Road Safety Audit Designers Response for: Highway Improvement Works Associated with Residential Development Talbot Road, Burnage

AMA Project Number: 21894

Updated Road Safety Audit: Stage 1

Report Produced for:	Manchester City Council
Report Produced by:	Jonathan Birkett
Report Dated:	19 Jan 2025
Report Reference:	MAL/RDTRBRSA1Rev0
Road Safety Audit Team Leader:	Jonathan Birkett

Drawn By:	MSF	Date:	05/10/2023
Checked By:	JF	Scale:	1:500
Drawing No.	AMA/21894/SK007		Paper size: A3
			Rev. P03

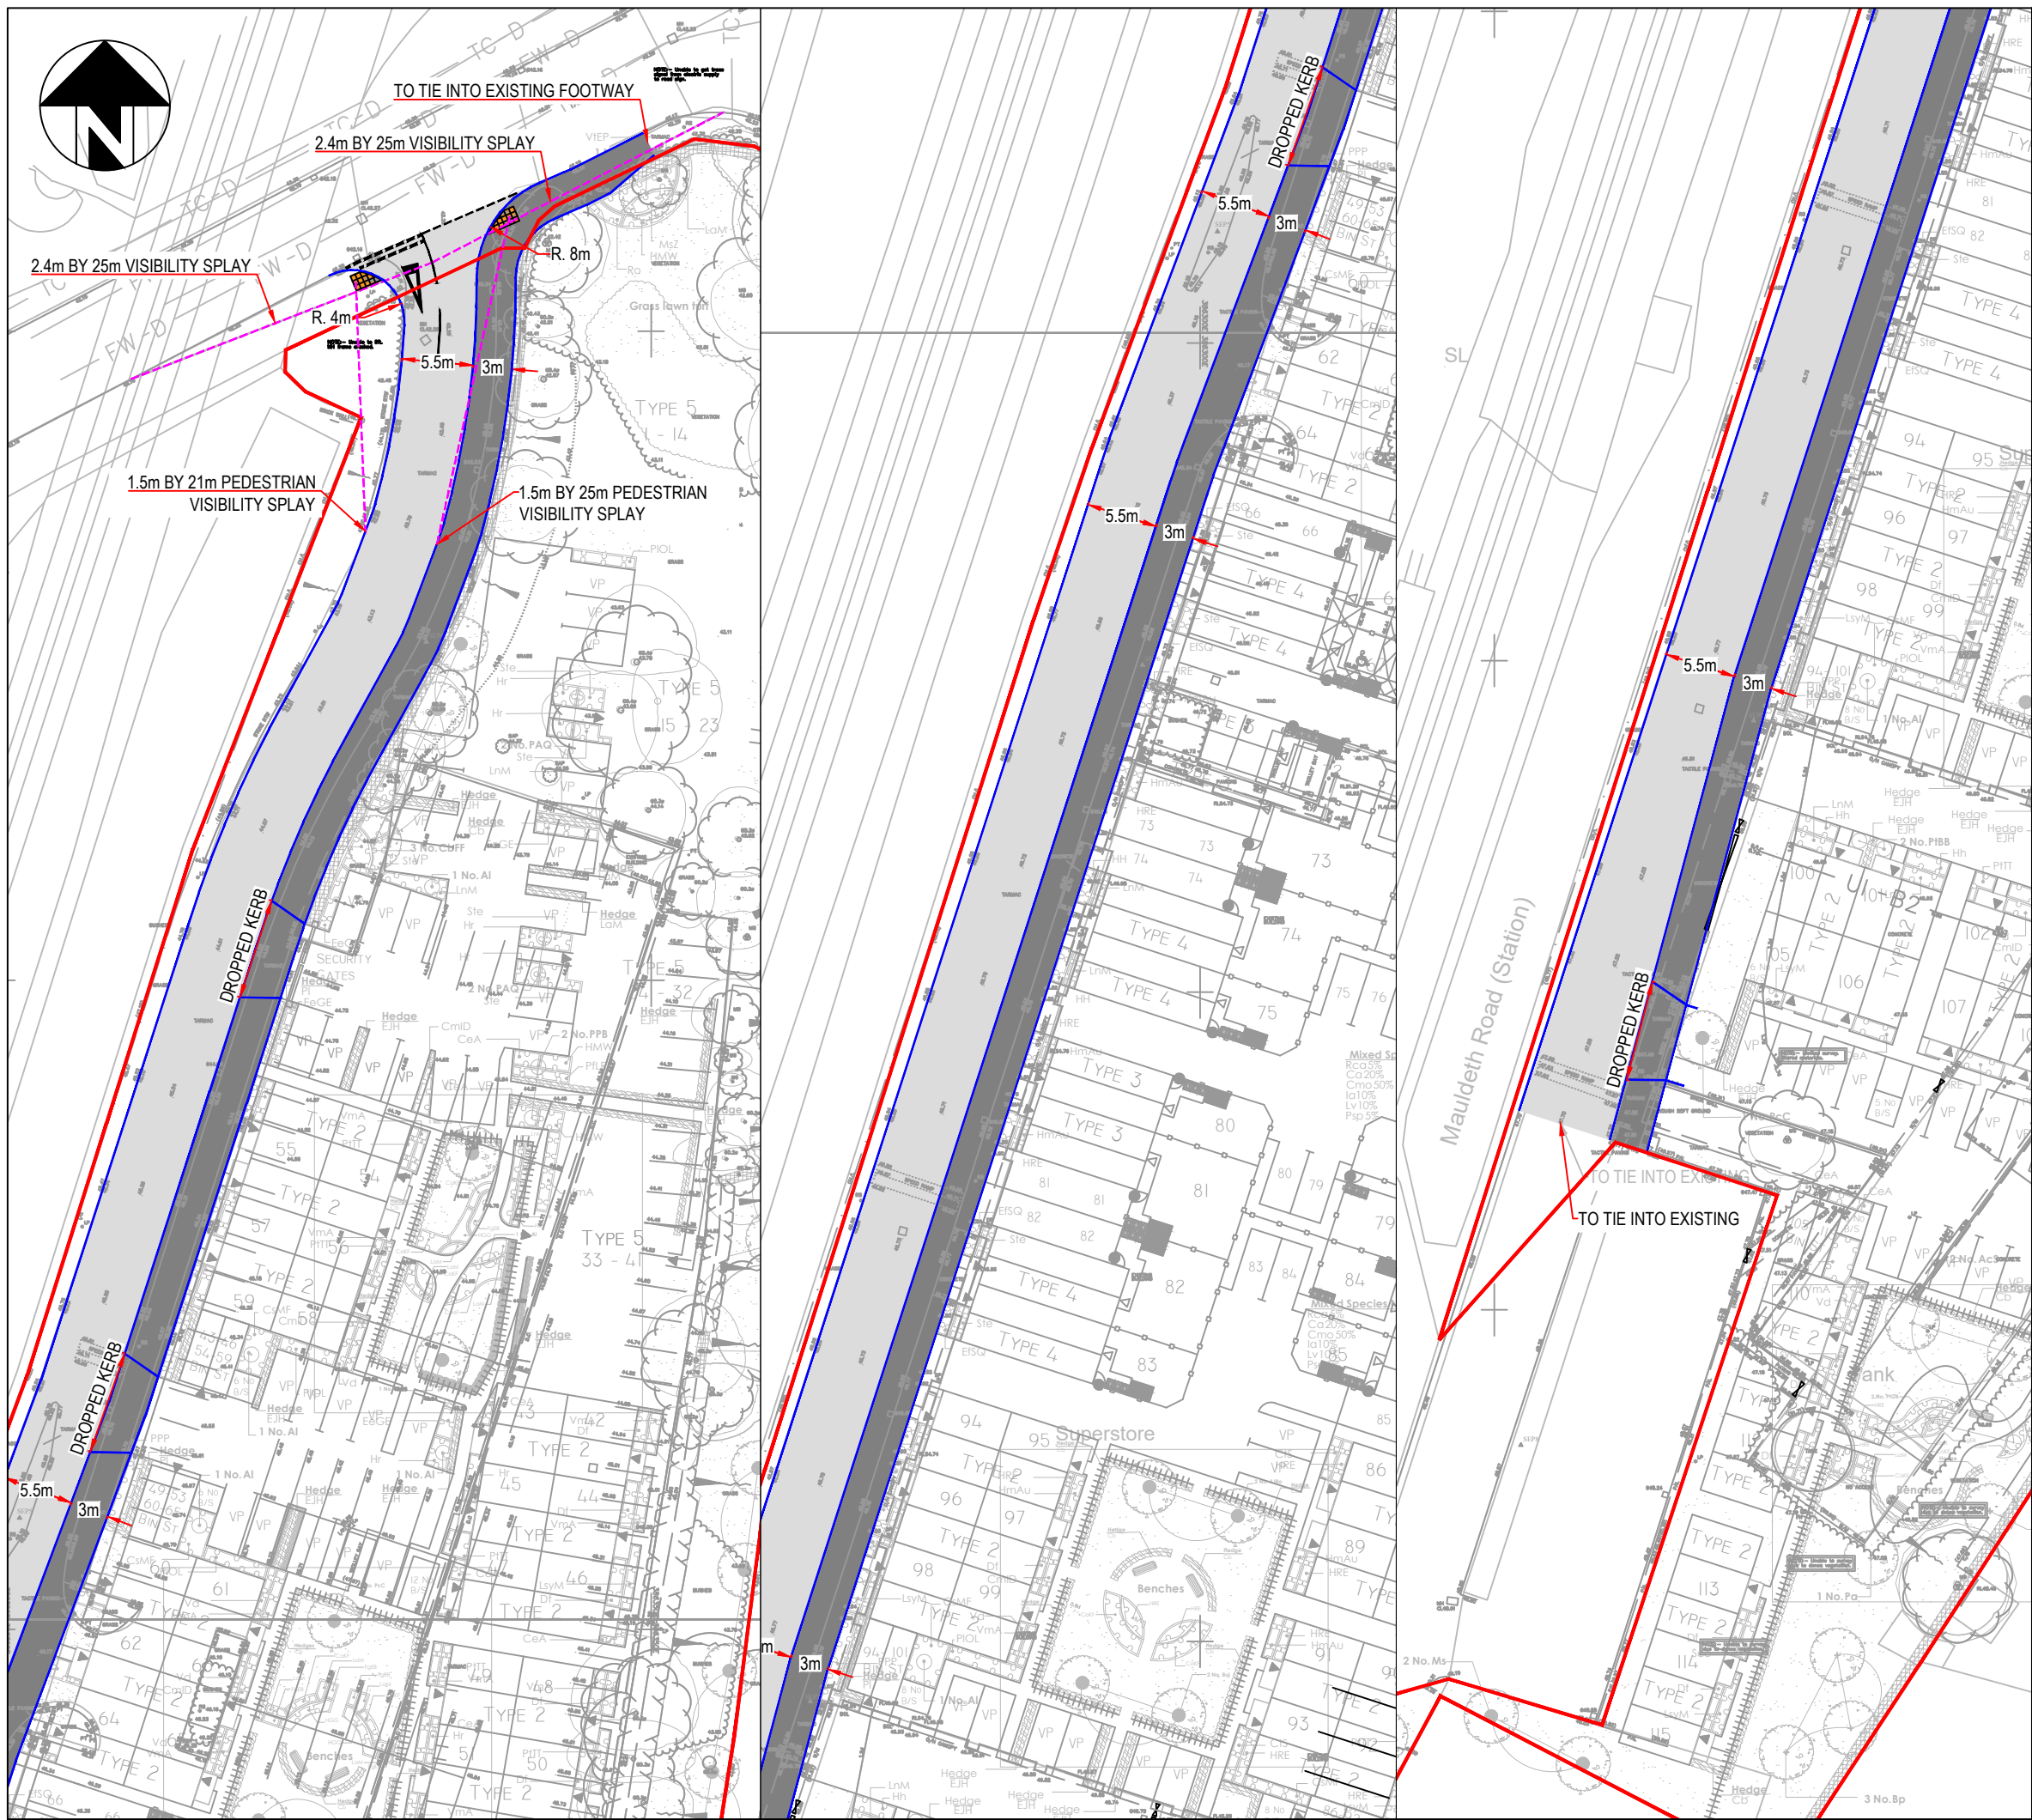
RSA Problem	RSA Recommendation	Design Organisation Response	Overseeing Organisation Response	Agreed RSA Action
As part of the works the existing priority junction with Talbot Road will be widened and the existing substandard uncontrolled crossings improved. It was noted whilst on site that moving the western crossing could result in obstructed visibility for pedestrians using the new crossing. Obstructed visibility will increase the risk of pedestrian/vehicle collisions.	It is a requirement that at an uncontrolled crossing visibility must be provided between approaching vehicles and pedestrians waiting at the crossing. Visibility splays of 1.5m x 25m must be provided. It was also noted that there is quite a lot of vegetation at this point as well.	AMA Drawing no. AMA/21894/SK007 P03 has since been amended to show the achievable pedestrian visibility splays from the junction of Talbot Road and the existing site access. Whilst on the eastern side of the road a full visibility splay is achievable (at 1.5m x 25m), on the western side of the road a 21m visibility splay is achievable. Given this is an existing access which will be improved as part of the proposed highways package to provide tactile paving, and there are no known highways safety issues at this particular junction in terms of road alignment or geometry, the marginally smaller than standard pedestrian visibility splay is not considered to represent a significant highways safety risk, especially when taking into account vehicles will naturally slow down as they enter / exit the junction.

PROBLEM		1-1
Location:	Talbot Road priority junction.	
Summary:	Obstructed visibility will increase the risk of pedestrian/vehicle collisions.	
As part of the works the existing priority junction with Talbot Road will be widened and the existing substandard uncontrolled crossings improved. It was noted whilst on site that moving the western crossing could result in obstructed visibility for pedestrians using the new crossing. Obstructed visibility will increase the risk of pedestrian/vehicle collisions.		
RECOMMENDATION		
It is a requirement that at an uncontrolled crossing visibility must be provided between approaching vehicles and pedestrians waiting at the crossing. Visibility splays of 1.5m x 25m must be provided. It was also noted that there is quite a lot of vegetation at this point as well.

RSA Problem	RSA Recommendation	Design Organisation Response	Overseeing Organisation Response	Agreed RSA Action
		Overall, it is considered that as this is an improvement to an existing uncontrolled crossing and it will not cause any additional highway safety risks.

P03	Amended to include pedestrian visibility splays	24/01/25	ECT
P02	Updated Site Layout Plan	18/10/24	ECT
P01	First Issue	DD/MM/YY	-
Rev	Description	Date	By
